CHANGES TO PROJECT DRAWINGS:

PROJECT: *Beatrice State Developmental Center - Central Heating Plant Upgrades*

DESCRIPTION: Addendum #2

PARTIAL BASEMENT DEMOLITION PLAN

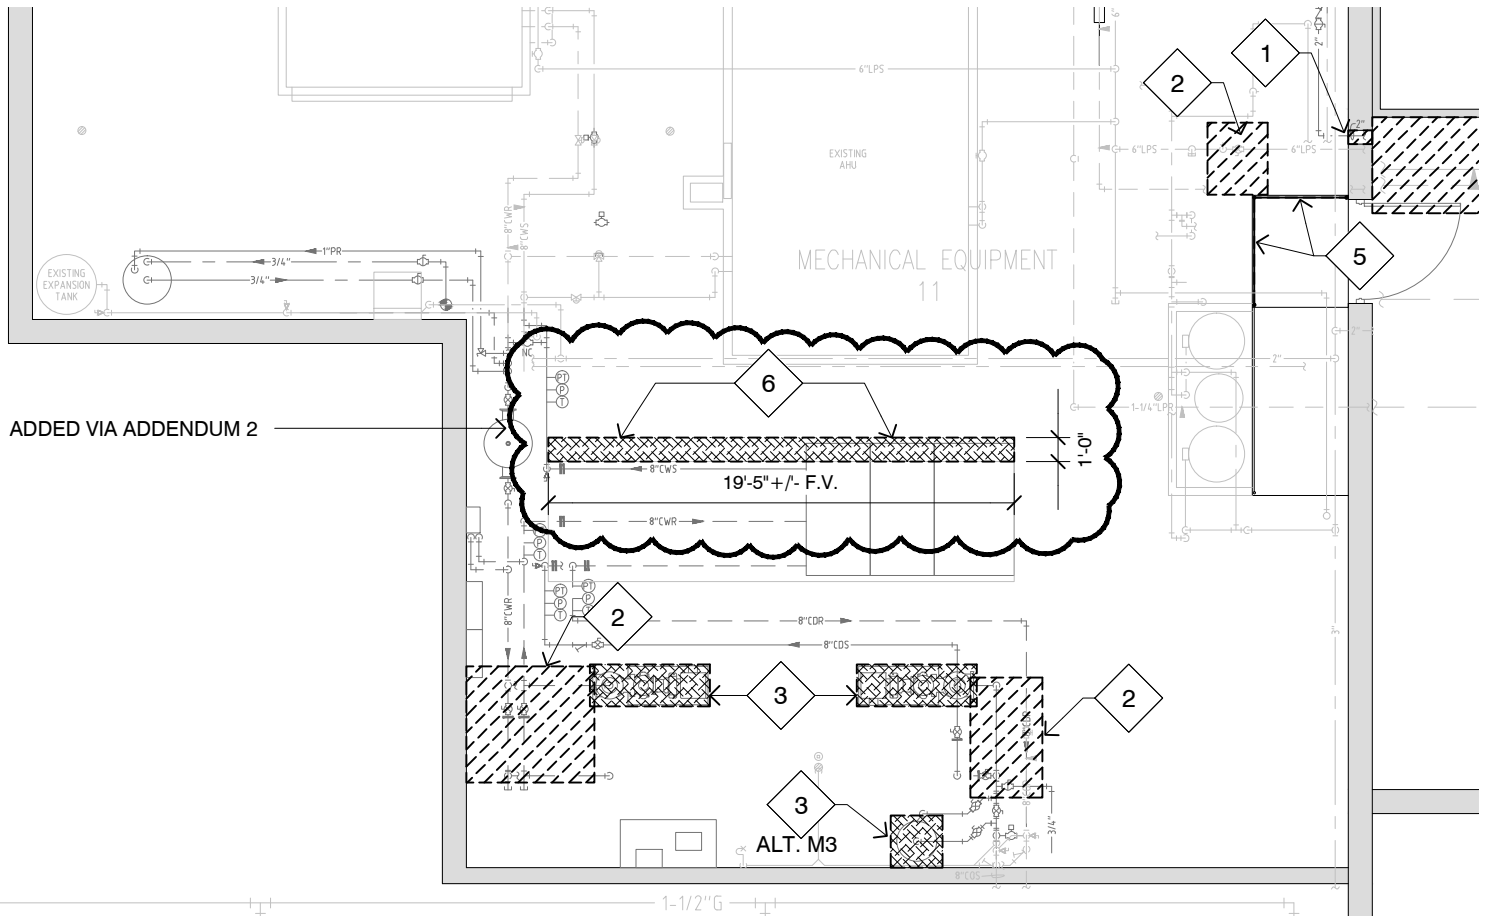
- 1) See attachment AD002.18A10-1 (clouded area) for area of existing concrete floor slab to be removed to allow for an extension to existing house-keeping pad.

- 6. DEMO PORTION OF EXISTING CONCRETE FLOOR SLAB - SAW CUT AND REMOVE 12" PORTION OF EXISTING SLAB TO ALLOW FOR EXTENSION TO EXISTING HOUSE-KEEPING PAD - SEE 18A2.0 FOR PAD EXTENSION.

PARTIAL BASEMENT FLOOR PLAN

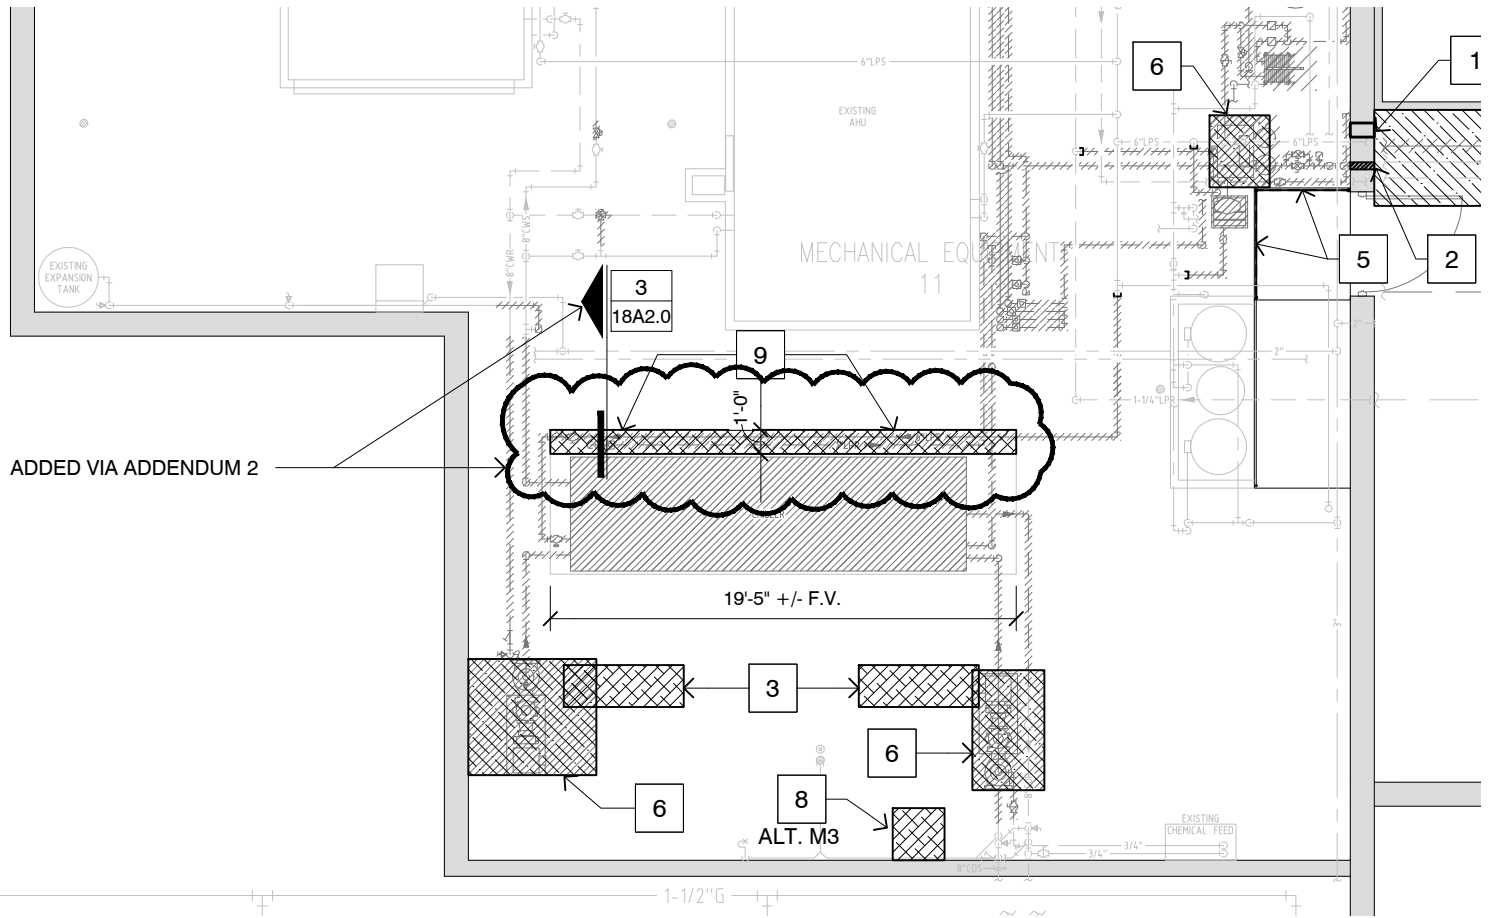
- 1) See attachment AD001.18A20-1 (clouded area) for new house-keeping pad extension.

- 9. CAST NEW CONCRETE HOUSE-KEEPING PAD EXTENSION (MATCH THICKNESS OF EXISTING PAD) - DOWEL AND EPOXY NEW AND EXISTING PADS WITH MIN. #4 REBAR AT 16" O.C. WITH MIN. 6" EMBEDMENT - PROVIDE 1/2" EXPANSION JOINT AT PERIMETER OF SLAB WITH COMPRESSIBLE FILLER AND URETHANE SEALANT - SEE DETAIL THIS SHEET.

3 HOUSE-KEEPING PAD EXTENSION DETAIL

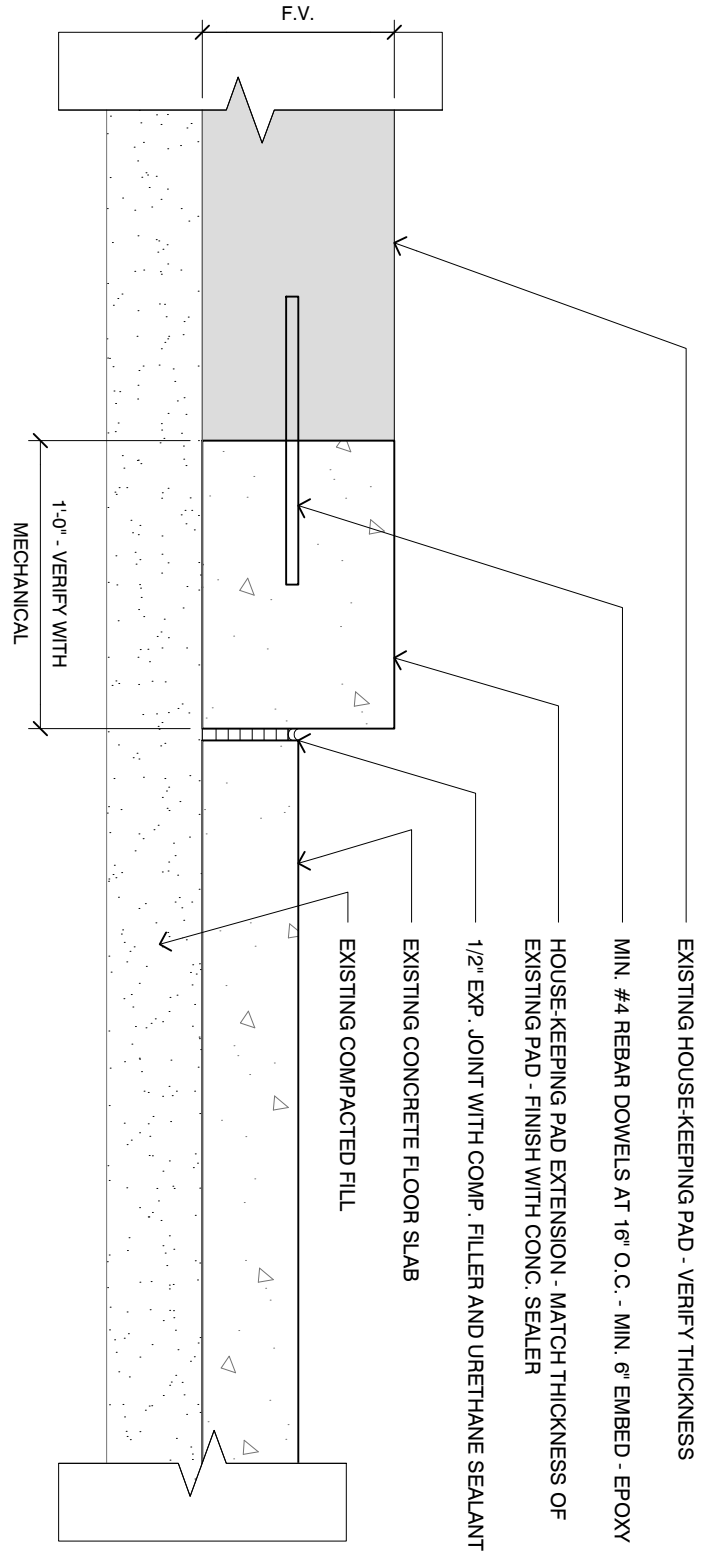
- 1) See attachment AD002.18A20-2 for detail at new house-keeping pad extension.

FIRST FLOOR DEMOLITION PLAN

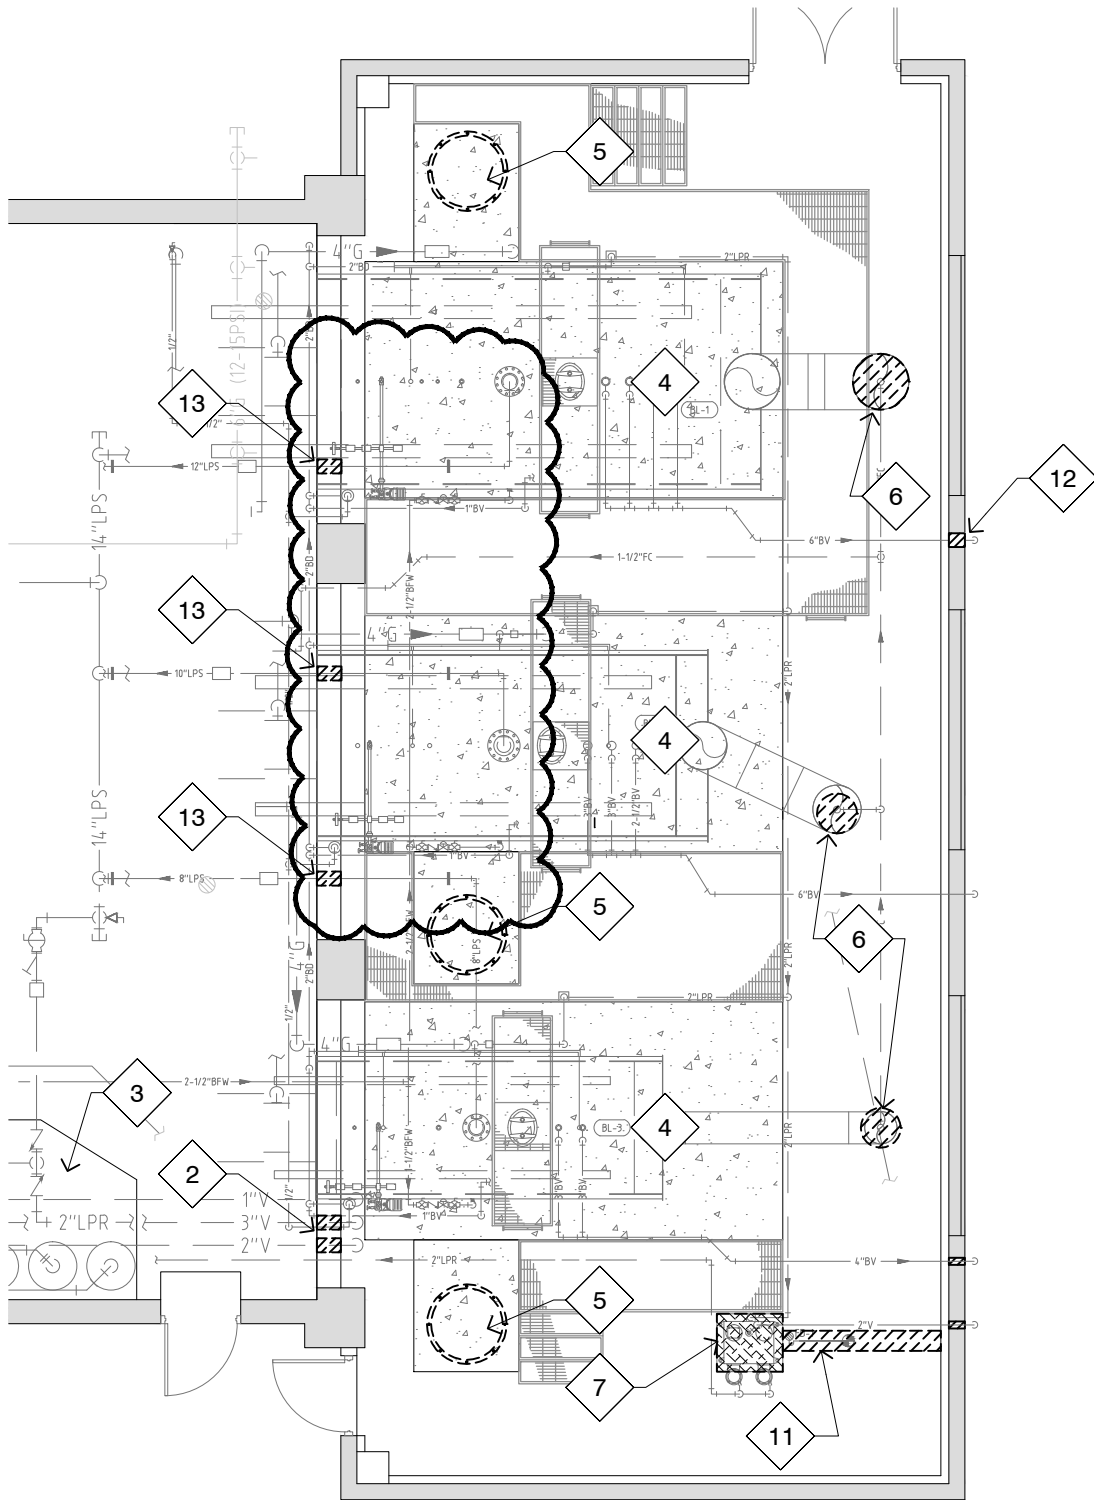
- 1) See attachment AD001.18A20-1 (clouded area) for location of existing wall openings that are to be made larger to accommodate new mechanical pipes. Coordinate with Mechanical on sizes of new pipes and adjust existing openings accordingly.

13. MODIFY EXISTING WALL PENETRATION AS REQUIRED FOR NEW PIPING PENETRATION - COORDINATE WITH MECHANICAL ON SIZE OF PIPE AND MODIFY OPENING ACCORDINGLY.

ADDENDUM: ADD02.P10-1

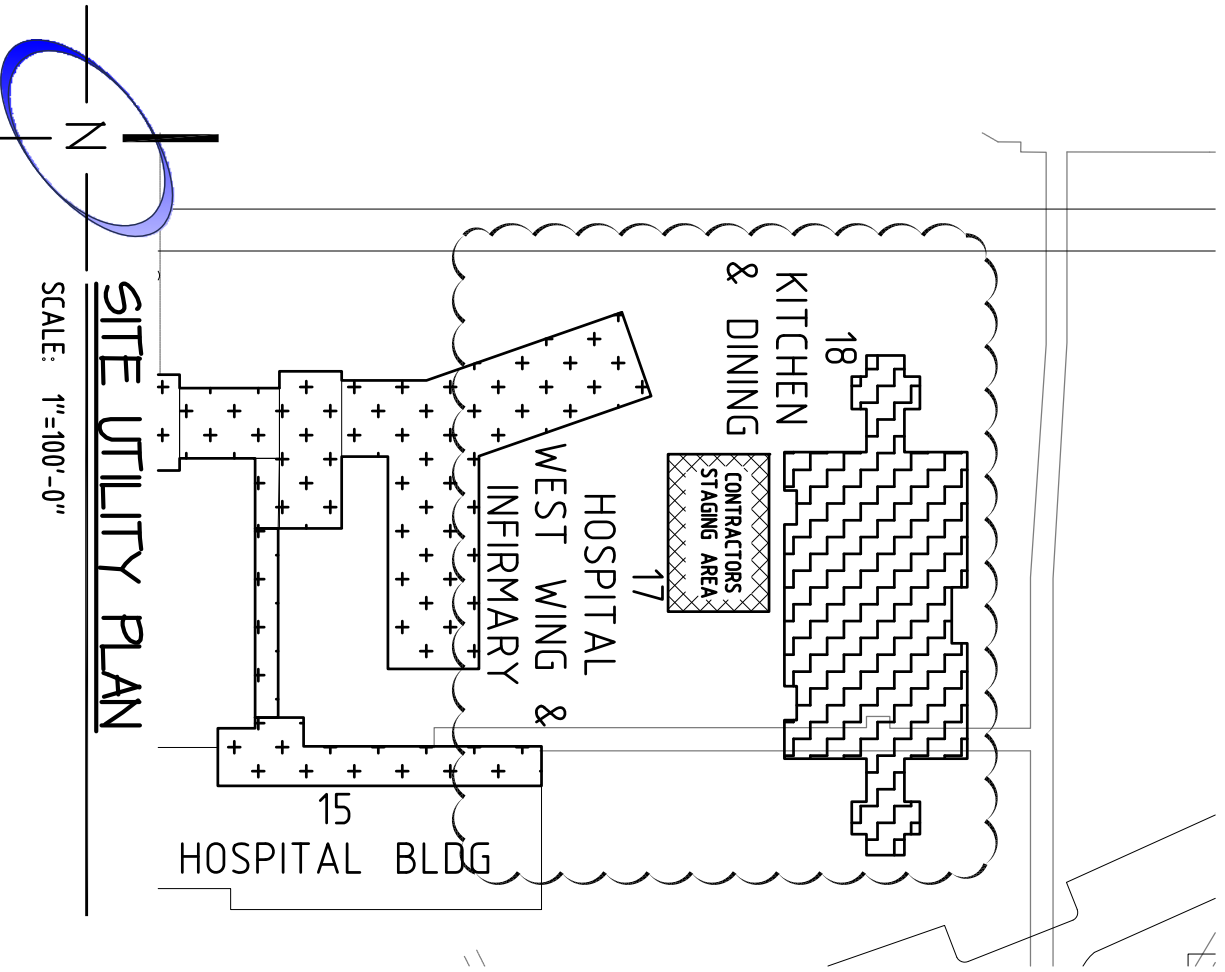
- 1) An additional staging area will be provided on the south side of the kitchen and dining building #18. See attached drawing ADD02.P10-1.
- 2) A General note shall be added that reads "All staging areas shall be fenced and locked at all times, coordinate closely with owner."
- 3) A General note shall be added that reads "All streets shall be kept open as much as possible, road block/ street shut downs shall be kept to a minimum and coordinated closely with the owner and local fire department."

- ANY WELDING, BRAZING OR SOLDERING DONE IN ANY BUILDING WITH RESIDENTIAL LIVING OCCUPANCY (BUILDING 28) MUST HAVE A FIRE WATCH PERSON DURING THE SAID WORK. ANY REQUIRED TEMPORARY SIGNAGE OR BARRIERS WILL BE THE RESPONSIBILITY OF THE CONTRACTOR.
- CONTRACTOR MUST COMPLY WITH ALL STATE AND FACILITY SAFETY RULES. ALL RULES WILL BE SUMMARIZED AT THE PRE BID MEETING.
- ALL TOOLS SHALL REMAIN SECURE, EITHER WITH THE CONTRACTOR DURING THE COURSE OF THE WORK DAY OR LOCKED UP AFTER WORK HOURS. ALL VEHICLES SHALL BE PARKED IN THE CONTRACTOR STAGING AREA UNLESS GIVEN PERMISSION TO PARK ELSEWHERE BY OWNER.
- ALL STAGING AREAS SHALL BE FENCED AND LOCKED AT ALL TIMES, COORDINATE CLOSELY WITH OWNER.
- ALL STREETS SHALL BE KEPT OPEN AS MUCH AS POSSIBLE. ROAD BLOCK/ STREET SHUT DOWNS SHALL BE KEPT TO A MINIMUM AND COORDINATED CLOSELY WITH THE OWNER AND LOCAL FIRE DEPARTMENT

BASEMENT DEMOLITION PLAN

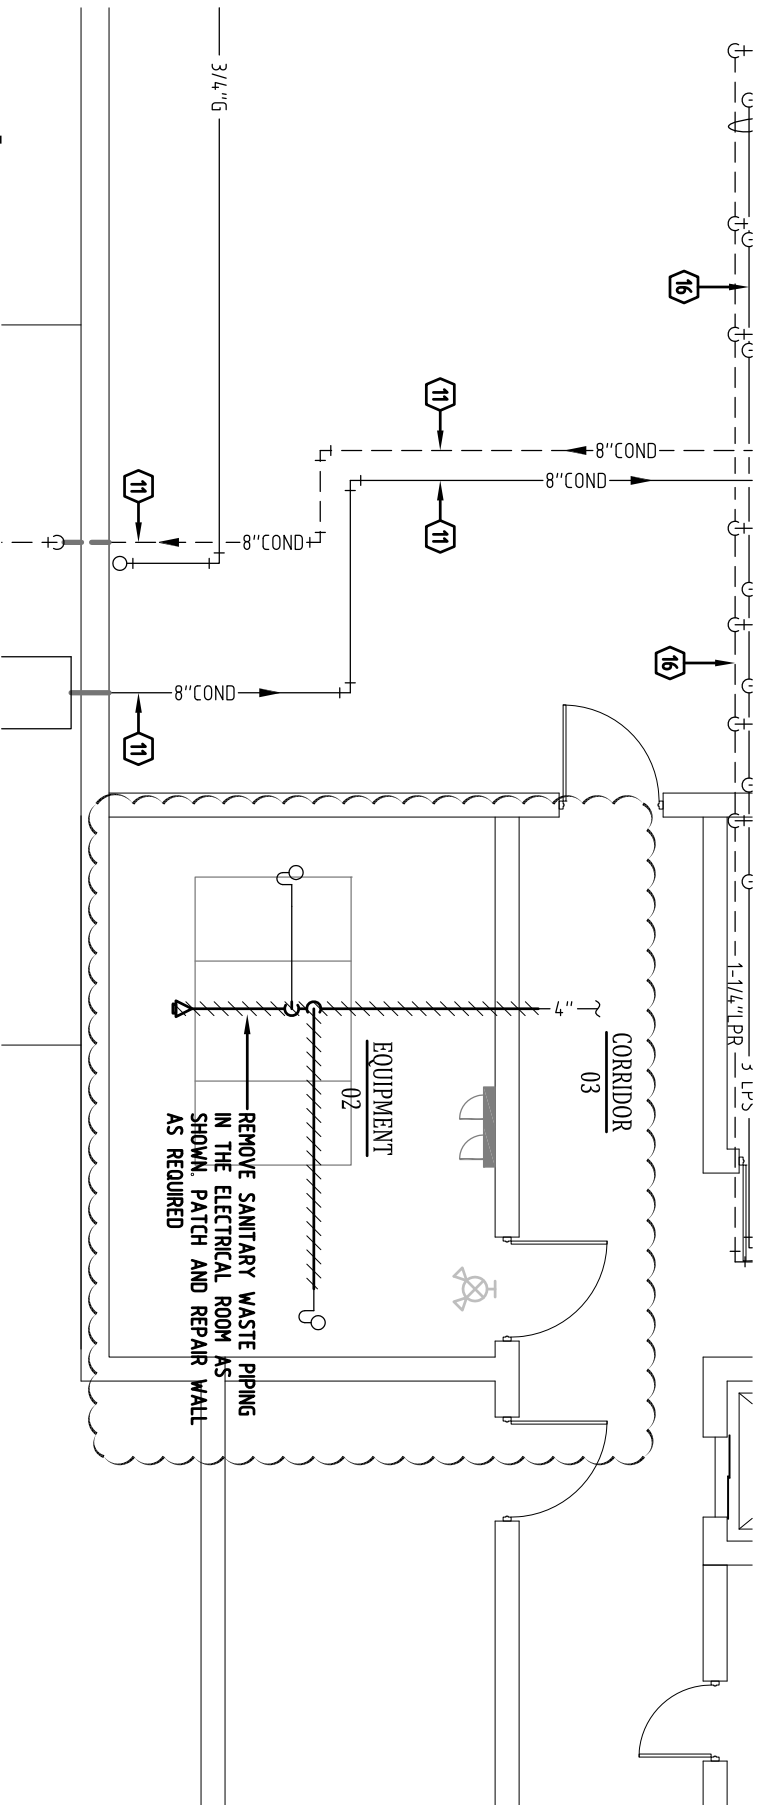
- 1) Remove sanitary waste piping in the electrical room as shown on ADD02.18M10-1.

BASEMENT MECHANICAL PLAN

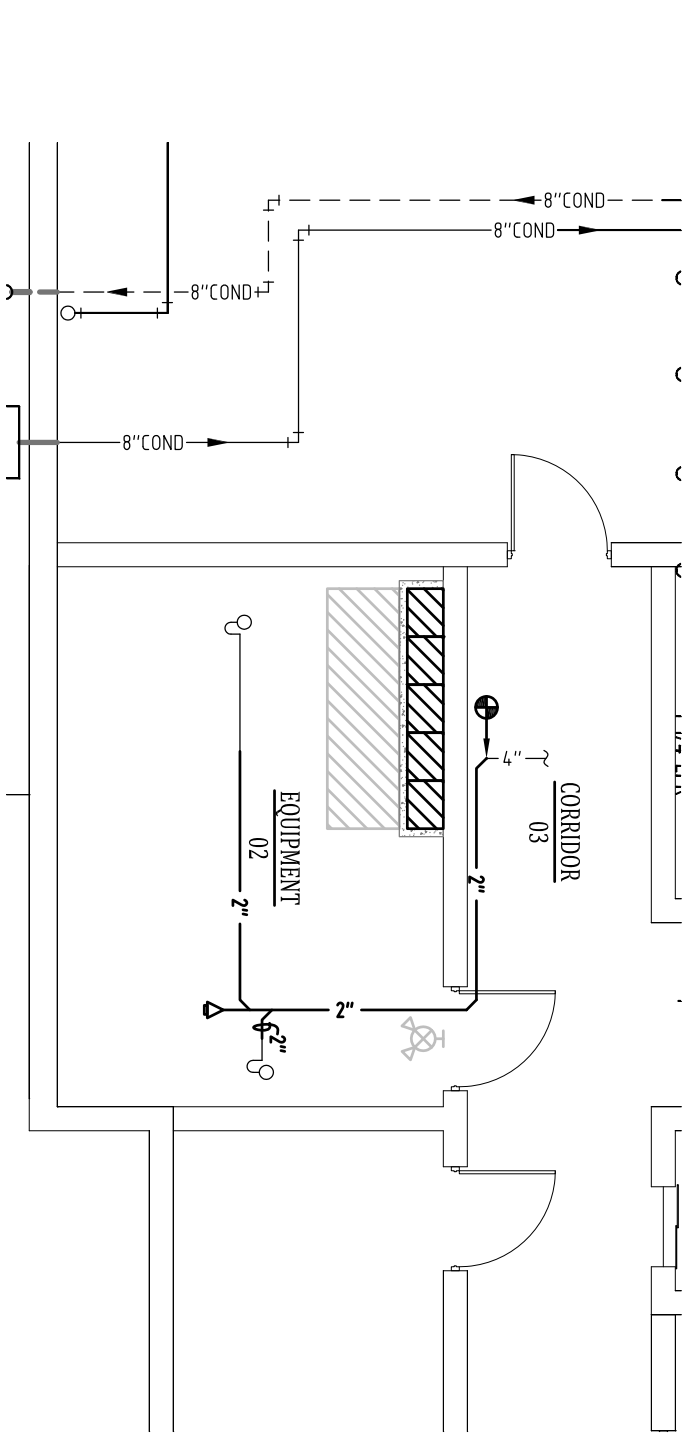
- 1) Install new sanitary waste piping in the electrical room as shown on ADD02.18M20-1.

DEMOLITION PLAN - STEAM & CONDENSATE

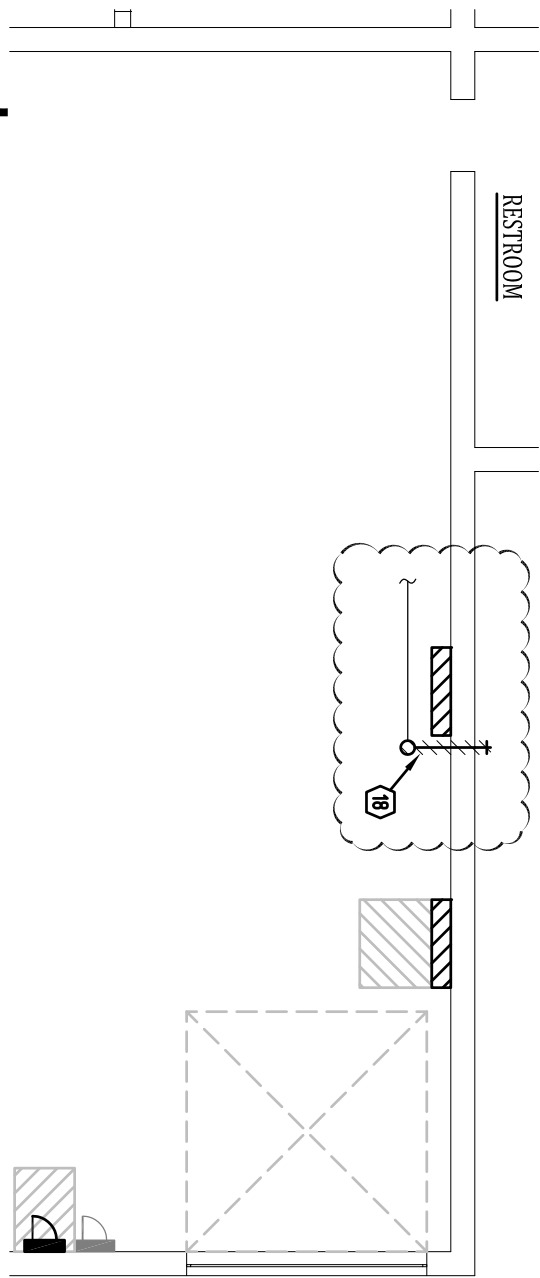
- 1) See attachment AD02.25M10-1, notes to remove existing rain water piping to extents shown

- 15. REMOVE EXISTING BULKHEAD WALL WATER PIPING. REMOVE ALL ASSOCIATED HANGERS AND SUPPORTS.
- 16. REMOVE EXISTING HIGH PRESSURE STEAM DRIP LEG STEAM TRAP AND PIPING TO CONDENSATE PUMP. CONDENSATE PUMP IS TO REMAIN.
- 17. REMOVE EXISTING DEAERATOR.
- 18. REMOVE EXISTING RAINWATER PIPING AS SHOWN. PATCH AND REPAIR WALL AS REQUIRED.
